### **SURREBUTTAL TESTIMONY**

## **JORDAN SEAVER**

## UNION ELECTRIC COMPANY D/B/A AMEREN MISSOURI

CASE NO. EO-2023-0136

Figure 2 – 2004 – 2021 System Peak Load with and without MEEIA

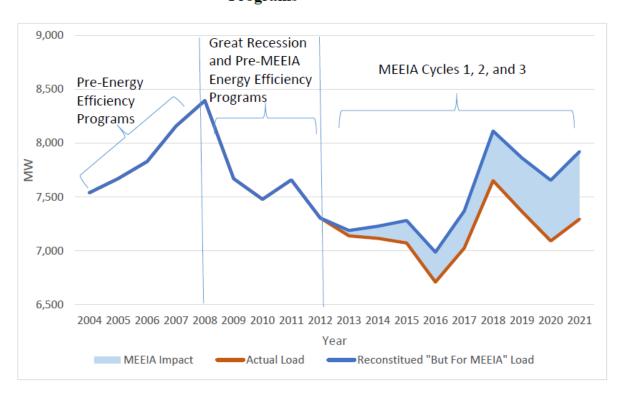
A. Yes, I do. Mr. Wills' Figure 2, on page 11 of his rebuttal testimony is provided as evidence that MEEIA, and energy efficiency programs in general, have done much to reduce the Company's system peak load. I have reproduced Figure 2 below.

The graph in this figure is of the MW of system peak load plotted over time, with special note of periods of energy efficiency. MEEIA cycles 1, 2, and 3 cover the time period of 2013 to 2021 in the graph. But during this time, there are increases and decreases of load that seemingly don't align with energy efficiency measures. For instance, there is a large dip from 2015 to 2016, a very large increase (at a higher rate than the compound annual growth rates Mr. Wills notes from 2004 to 2008) from 2016 to 2018, then another large and steep dip from 2018 to 2020, with a slightly slower rate of increase beginning at the

front end of 2020 again. This graph is not helpful in determining what, if any, effect MEEIA cycles have on system peak load for Ameren Missouri. It isn't helpful in this way precisely because these increases and decreases in load during times when energy efficiency programs are implemented are not obviously caused by said programs. We could just as easily say that this graph shows that energy efficiency programs increase load.

- Q. But doesn't Mr. Wills say that the graph shows the "reconstituted 'but for' MEEIA load?" Is this not an indication that MEEIA programs reduce the system peak load by that amount—the shaded portion—shown in the graph?
- A. The graph does include a departure for the counterfactual (in the divergence between the actual load line and the possible non-MEEIA line). It shows the system peak load for the possible world with no MEEIA from 2013 to 2021. The problem is that this counterfactual load is all assumed, and not actually perceived. The capacity savings have not been observed and measured, because much of what they claim is avoided demand is at best wishful thinking based on assumptions about, e.g., the average hours of use of a light bulb, or the reduction in MWs required to heat a home to a certain temperature in a certain time (all highly idealized facets of the assumption).

The graph basically says that MEEIA is assumed to reduce the load by some amount, but nothing more than this, which is already an assumption (as seen in MEEIA<sub>2</sub> counterfactual). It is, in my opinion, begging the question<sup>11</sup> to say that MEEIA reduces load because the support for the reduced load is simply the assumption that it will be reduced. The Company reasons the following way: "MEEIA reduces load, and we know this because the point of MEEIA is to reduce load. So, we made a graph showing our

- A. That is not correct. The graph presented by Mr. Wills in Figure 2 on page 11 of his rebuttal testimony in this case shows what the assumed savings for MEEIA are. These savings are in some cases estimates, in some cases actual attempts at measurements, and in some cases are merely what the Company assumed it would save with certain programs. The cases in which measurements may be able to be made (e.g., business demand response) are small reductions in demand relative to the "reconstituted" possible MEEIA load shown in Figure 2. What I am talking about above is a situation where the Company has made most of its programs tied to actual, directly recorded decreases in load.
